City of Alexandria, Virginia

MEMORANDUM

SUBJECT: RECEIPT OF REPORT ON THE WOODROW WILSON BRIDGE PROJECT PLANS FOR JONES POINT PARK AND THE URBAN DECK AND SETTING THE REPORT FOR PUBLIC HEARING ON SATURDAY, NOVEMBER 18 AND COUNCIL CONSIDERATION ON TUESDAY, DECEMBER 12

ISSUE: Receipt of report on the Woodrow Wilson Bridge project plans for Jones Point Park and the Urban Deck

Site Plan

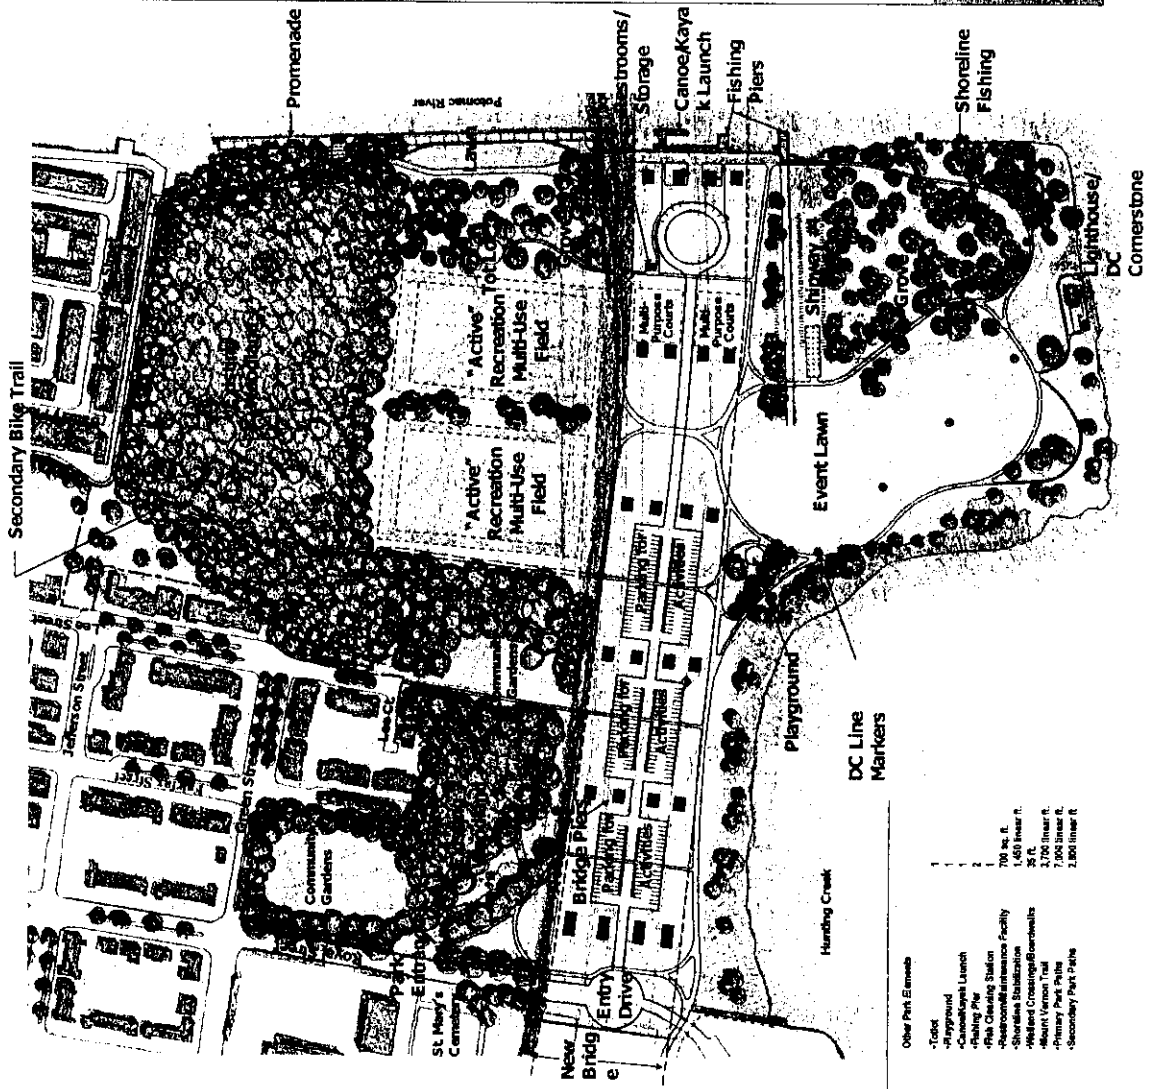
1. In general, the design of Jones Point Park is compatible with the guidelines the Park and Recreation Commission initially gave to the project.
2. The current plans show two athletic fields side-by-side north of the bridge. This is true of both the interim plan and the plan for final build out of the park. Though the Jones Point Park Stakeholder Panel debated this at length because it would necessitate some tree removal, they finally endorsed the current configuration. The Park and Recreation Commission strongly believes the fields must be located together in this location. The long-term utility of the fields and the Recreation Department's ability to meet changing recreational demands over time is increased substantially by having them located together. Additionally, this configuration keeps all the active recreation, along with the attendant noise, in one location to the north of the bridge. This leaves the portion of the park south of the bridge for more passive uses. This is appropriate as the southern part of the park contains the historic resources (the lighthouse, the corner stone, and the ship ways) that will become featured cultural resources of the park. A play field should not compromise the design of the park around these historic features.

4. The hard surface area for courts needs to be further developed.
5. The restrooms and the tot-lot should be located near the athletic fields as is shown in the current plan.

6. The waterfront should be kept for canoe/kayak launch only.
7. Wetland areas should be preserved and maintained.
8. A comprehensive maintenance plan needs to be developed between the National Park Service and the City of Alexandria with resources available to maintain all the design components.

The AAC endorses the concept plan for Jones Point Park, subject to the following recommendations:

- The concept plan assumes that the majority of the numerous extant foundations associated with the early 20th century shipbuilding era will be buried and commemorated, along with the other historic resources, by the placement of only nine interpretive panels or signs to reflect 7,000 years of human occupation. None of the suggested treatment proposals contained in the Memorandum of Agreement is listed as part of the concept plan's proposed mitigation of the below-ground historic resources, other than interpretive signage and retention of the finishing pier and one of the four shipways. Moreover, the concept plan does not seriously consider leaving any of the extant foundations exposed, and sealed for protection, for interpretation to the public. To the extent that burial is required due to recreational uses of the area on which they are located, or for protection of the cultural resources, the AAC believes that care should be taken to ensure that the soil used protects the

- The AAC additionally believes that the interpretation of the historic resources referred to in the concept plan is insufficient and incomplete. Several significant historic resources are either not included in the plan or are scarcely mentioned, including among others, the D.C. boundary marker, the Historic Lighthouse, the Virginia/Maryland boundary marker, and the Signal Corps light tower base.

- The AAC notes that the concept plan for cultural resources incorrectly identifies some of the historic resources, such as attributing the ropewalk and the farming to the colonial era. The Park planners verbally assured the AAC at the August 16th meeting that these errors would be corrected prior to any official submission. If not properly addressed by the Park planners in their submission to the City, then these errors must be corrected.

Staff does not support changing the proposed plan in this way. With respect to the athletic fields, a goal of the plan, as noted above and supported by the Park and Recreation Commission, is to separate active and passive recreation by keeping passive activities to the south of the bridge and active recreation on the north side. There are approximately 21 acres of woodland north of the new bridge. Under the plan, approximately four acres of woodlands will be cleared. Studies conducted on the north side show that only nine trees with a caliper of 24 inches or more will be removed, and of these nine trees, two are in poor health. Because this area was originally a fill site for river spoils

Staff supports the secondary bike trail for the same reasons the Park and Recreation Commission and the Bicycle Study Committee do: a) it allows faster cyclists to use the secondary path and slower cyclists to use the riverside path, thereby reducing potential conflicts between walkers and cyclists traveling at fast speeds, b) it allows more people to use the central part of the park which will increase safety, and c) it gives the Police the ability to patrol the wooded area. In addition, staff believes the impact to trees and wetlands will be minimal. As part of the 90% plans, staff will incorporate designs sensitive to trees and wetlands.

Interim Park Improvements Plan

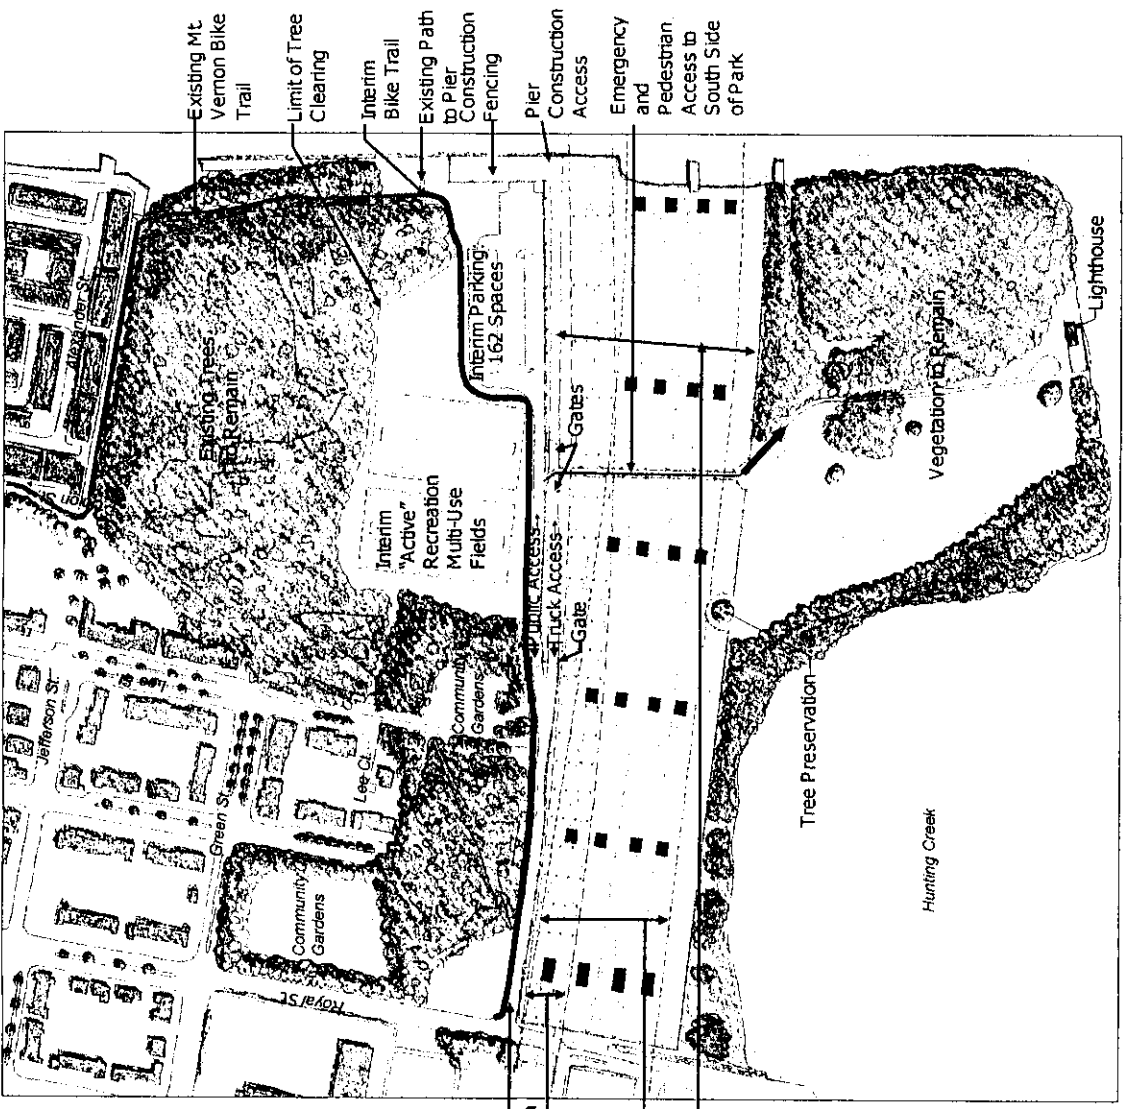
7. We are particularly pleased that the interim plans include keeping the Mt. Vernon trail segment open during construction. If closing of the interim path is necessary during construction, it should not be closed without there first being a route planned and marked to use as an alternative during the closure periods. Further, we recommend that the interim trail work include repair to the tree root and other damage to the path from where it turns south at Ford's Landing to where it joins the current park road. This segment of the path is in no condition to last until a new trail is built.

In addition to approving the 65% design for the Jones Point Park, Council also needs to approve an interim (during construction) plan for the park. The proposed interim plan (Attachment 2) shows the athletic fields in the approximate location of the fields in the final design. The interim fields would be smaller, but the north and west boundaries would remain constant in both designs. In the final design, the athletic fields would expand to the south in the area presently occupied by the Jones Point Park road and the current bridge. To the east, the interim plan shows a 162 space parking lot to replace the parking lot currently at the west end of the bridge used by City employees. After the bridge construction is complete, this interim parking lot would be replaced with a tot play lot and additional trees, and parking for all cars would be under the bridge. It is important to note that if the interim plan is accepted, no more understory (limbing trees and removing underbrush) and trees will need to be removed than in the recommended final plan. The interim plan was presented at the Board and Commission meeting on August 14, the September 6 meeting at the Lyceum and was approved by the Park and Recreation Commission in September.

Urban Deck
Location Map

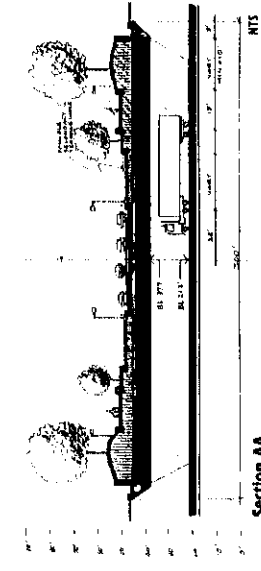
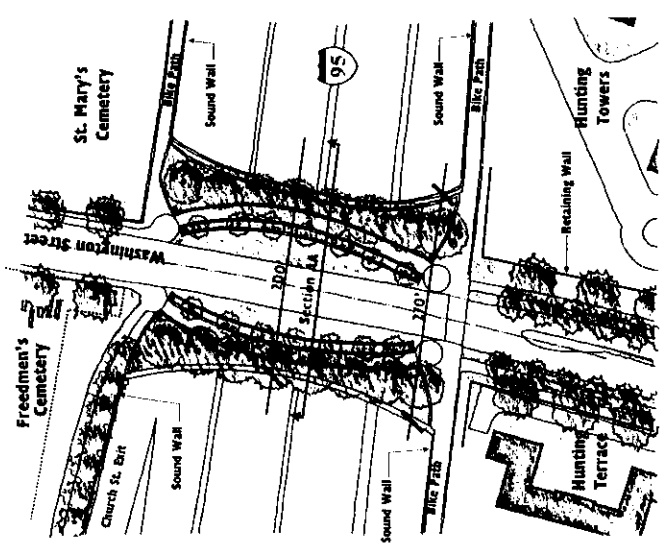
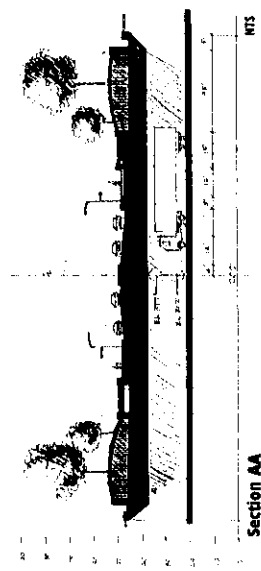
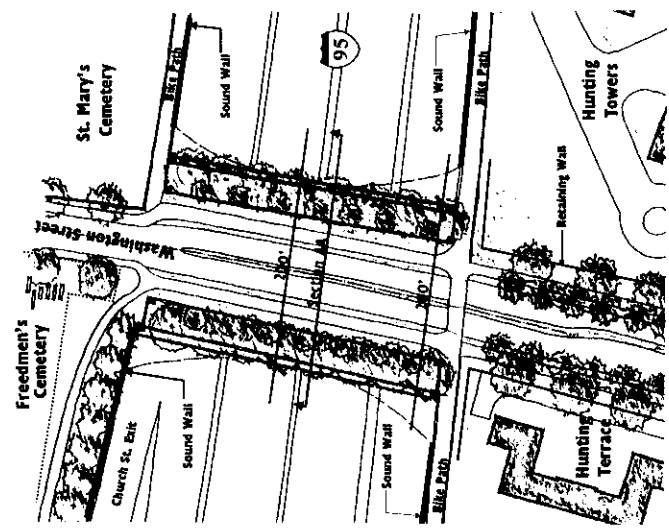
The Park and Recreation Commission and the Waterfront Committee support the smaller deck provided the following issues are addressed: noise and air quality studies show no greater impact on neighbors (noise and air quality are discussed below); recreation fields in the R.O.D. and the settlement agreement are located elsewhere (the City is pursuing this); curvilinear design is favored with a larger deck designed on the east side of Washington Street to provide greater enjoyment by the users of the trail over the bridge; and consideration be given for bas relief sculptures depicting historic events in Alexandria on the sound walls at the southern entrance to the City (staff will discuss with Potomac Crossing Consultants).

Friends of Freedmen’s Cemetery supports a deck which extends to the maximum possible distance to the east and west and the least possible distance to the north and south, while supporting passive recreation and reducing the noise and visual intrusion of the Beltway. The Environmental Policy Commission supports the “Streetscape” concept and suggests the Urban Deck be planted with native trees and other native vegetation to enhance the value of the deck for passive recreation and as a quality wildlife habitat.

- a. Noise and air quality studies show that there will not be a greater impact on the neighbors.
- b. Recreation fields promised in the R.O.D. and as part of the court settlement are located elsewhere in the City.
- c. The curvilinear design was favored with a larger deck designed on the east side of Washington Street to provide greater enjoyment by the users of the trail over the bridge.
- d. Sound walls are aesthetically pleasing. Consideration should be given for bas relief sculptures depicting historic events in Alexandria on the walls at the south entrance to the City.

6. We are pleased to see the multi-use path from the Rt. 1 interchange connection to the Urban Deck. While we recognize that the Urban Deck drawings are very preliminary, we do want to note that they do not show a multi-use path design that is friendly to through bike or rollerblade traffic. Several comments apply: the turning angles need to be considerably less severe; if the connection to the bridge is going to be through the minimum deck design, consider widening the east side of the deck somewhat to accommodate the multi-use path; if the Mt. Vernon Path could be realigned along the river, the connection from the Rt. 1 path for cyclists may be able to be aligned to coincide with the light at the Hunting Terrace intersection. Pedestrian traffic going into Old Town from the Rt. 1 area should still be routed directly up to the urban deck (to minimize pedestrian travel distances), to cross the urban deck on the west to the light at Church St. If these configurations are not possible, a pedestrian/bicycle activated light would be an absolute necessity to cross Washington St. just south of the Urban Deck.

The AAC supports the smaller urban deck for **Washington Street**. This will help to protect the cultural resources in Freedmen's Cemetery and provide a fitting gateway to the historic City of Alexandria. The AAC supports multiple features, including cultural resources, at the **Jones Points Park**. We conclude that further, more careful investigation of cultural resources is needed in order to provide an adequate basis for interpretation and protection. Finally, the AAC believes maintenance plans are needed for both Washington Street and Jones Point Park. Our letter provides details on these recommendations.
